MATTERS FOR LIVERPOOL LOCAL PLANNING PANEL DETERMINATION

Monday the 27th of June 2022

ITEM No.	SUBJECT	PAGE No.
1	<p>Planning Proposal RZ-6/2021</p> <p>PLANNING PROPOSAL TO AMEND HOB AND FSR OF THE LLEP 2008 RELATING TO LAND AT 61-71 GOULBURN STREET, LIVERPOOL</p> <p>SP 18729, LOT 8 SECTION 41 DP 758620, LOT 20 DP 1113807, LOT 1 DP 25642, LOT 2 DP 610334 AND LOT 1 DP 610334</p> <p>61-71 GOULBURN STREET, LIVERPOOL</p>	3-26

Item no	1
Application Number	RZ-6/2021
Proposal	Planning proposal to amend HOB and FSR of the LLEP 2008 relating to land at 61-71 Goulburn Street, Liverpool
Recommendation	Proceed to Gateway determination
Planning Officer	Cameron Jewell, Senior Strategic Planner

Discussion on building separation

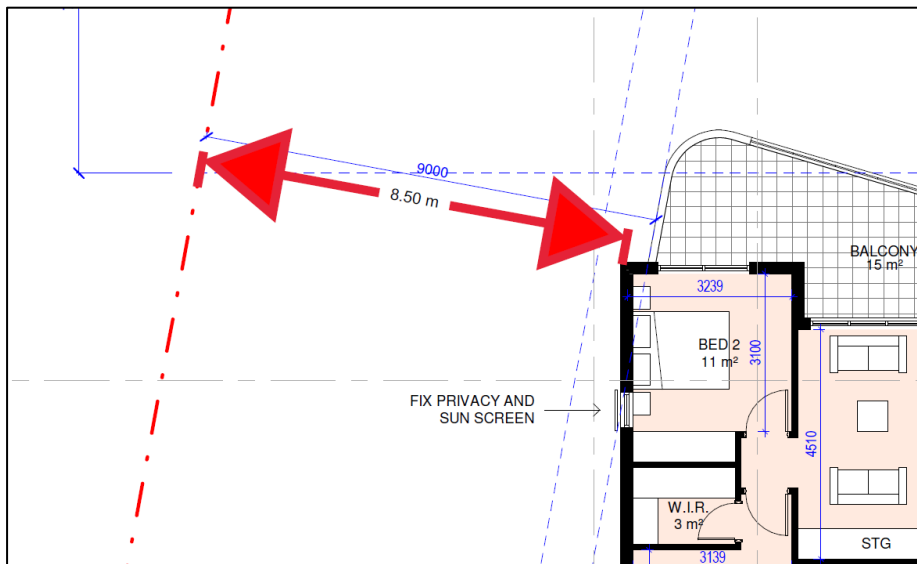
The relevant discussion in terms of building separation is the boundary to west (side) where potential RFB's may be constructed in the future.

The side setback provided on the western boundary for Level 4 is typically 9m or greater. However, as shown in the figure below, the setback of the corner of the north-western unit, Unit 18, encroaches within the building separation requirement of the ADG.

The prescribed setback is 9m to achieve a building separation of 18m prescribed in the ADG. The

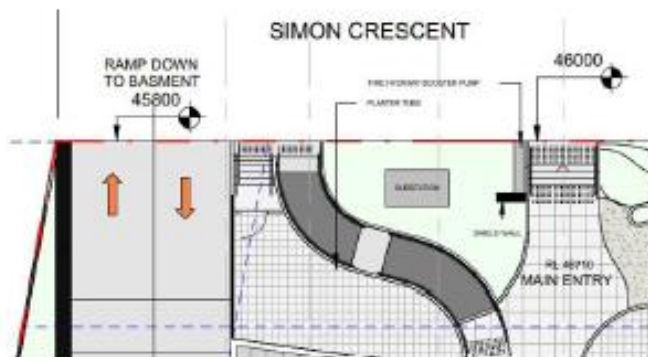
Council Comment	Response
Planning	
<ul style="list-style-type: none"> • Utility services: The substation should be concealed from view from the street and integrated into the architecture of the building. Overhead power cables should be placed underground with overhead electricity infrastructure removed. Street lighting shall be installed using multi-function poles. Landscape Plan shall include provision to soften the view around the substation 	<p>The proposed substation will be located along the Simone Crescent frontage and will be located adjacent to the driveway in order to reduce its visual impact on the street.</p>

From Endeavour Energy's perspective the fact that provision is being made for a padmount substation is a positive. Endeavour Energy's general requirements is for a padmount substation to be at ground level and have direct access from a public street (unless provided with appropriate easements for the associated underground cables and right of access).

A4.3 - Padmount easements and clearances

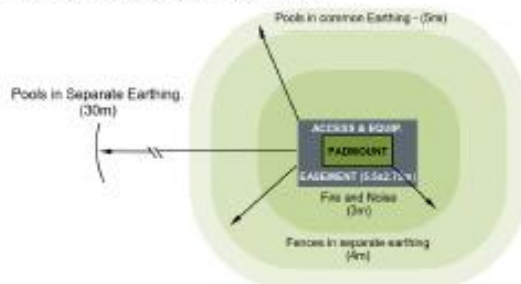
As shown in the following extract of Endeavour Energy's Mains Design Instruction MDI 0044 'Easements and Property Tenure Rights', Figure A4.3 'Padmount easements and clearances', padmount substations require:

- Easement with a minimum size of 2.75 x 5.5 metres (single transformer).
- Restriction for fire rating which usually extends 3 metres horizontally from the base of the substation footing / plinth and 6 metres vertically from the same point.
- Restriction for swimming pools which extends 5 metres from the easement.

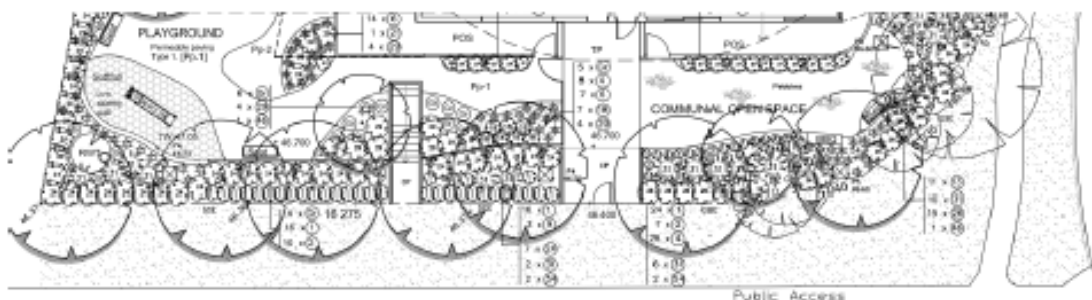
The planting of large trees near electricity infrastructure is not supported by Endeavour Energy. Particularly for overhead power lines, ongoing vegetation management / tree trimming is a significant network cost and falling trees and branches during storms are a major cause of power outages.

Suitable planting needs to be undertaken in proximity of electricity infrastructure (including any new electricity infrastructure required to facilitate the proposed development). Only low growing shrubs not exceeding 3.0 metres in height, ground covers and smaller shrubs, with non-invasive root systems are the best plants to use. Larger trees should be planted well away from electricity infrastructure (at least the same distance from overhead power lines as their potential full grown height) and even with underground cables, be installed with a root barrier around the root ball of the plant.

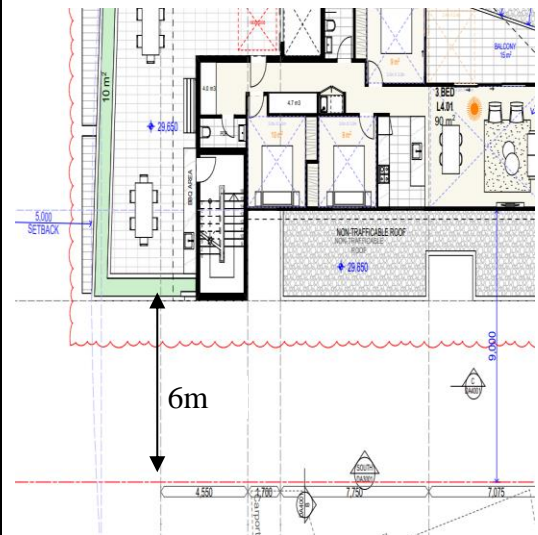
See discussion below on building separation/setbacks:

North-west (side): The proposed development adjoins a laneway 6m in width therefore would be subject to a side setback of 3m (1-4 storeys) and 6m (5-8 storeys) to Harvey Pathway to achieve appropriate Building Separation. The proposal provides a minimum of 3m setback for Ground to level 3 and 6m for level 4. Therefore, achieving compliance.

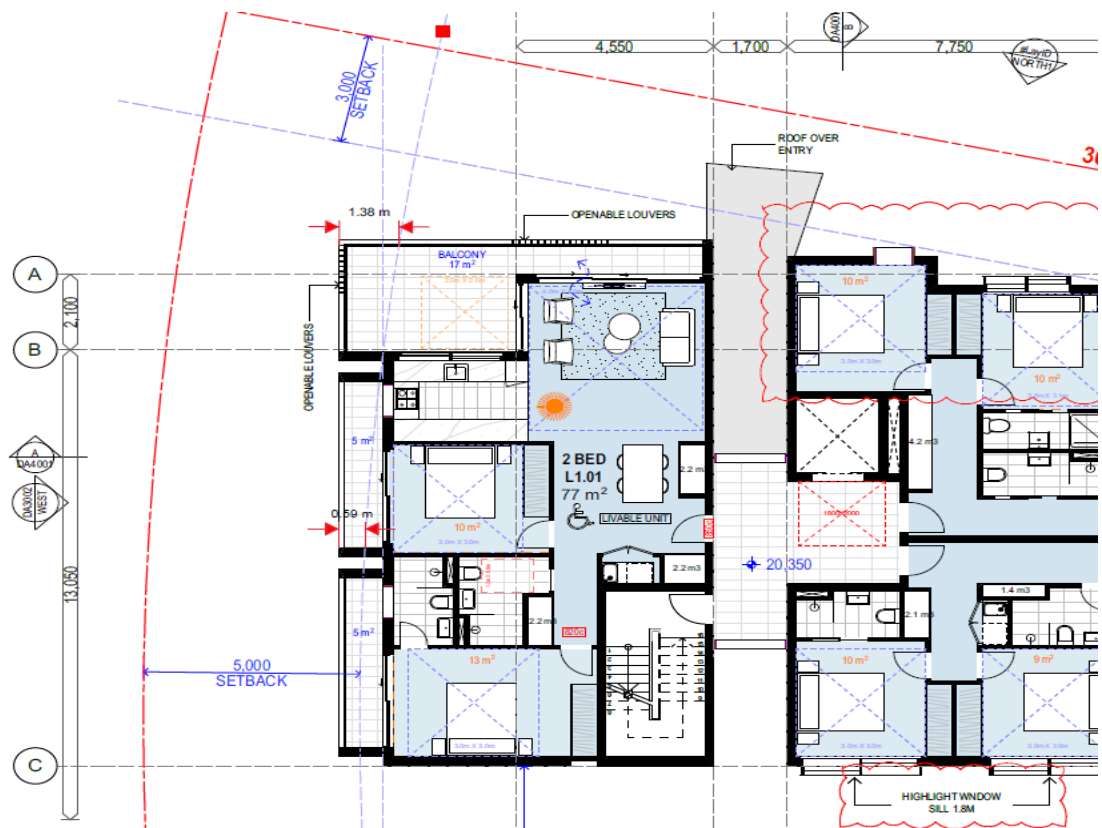
The front boundary has an arched configuration and an irregular shaped building configuration is the result. The building façade design provides a desirable articulation to the streetscape.

It should be noted that the proposal complies with FSR and maximum building height development standards and is not considered to be an over development of the site with regards to the LLEP 2008. The objective of building setbacks to provide reasonable space for landscaping, open spaces and solar access, visual and acoustic privacy has not been compromised.
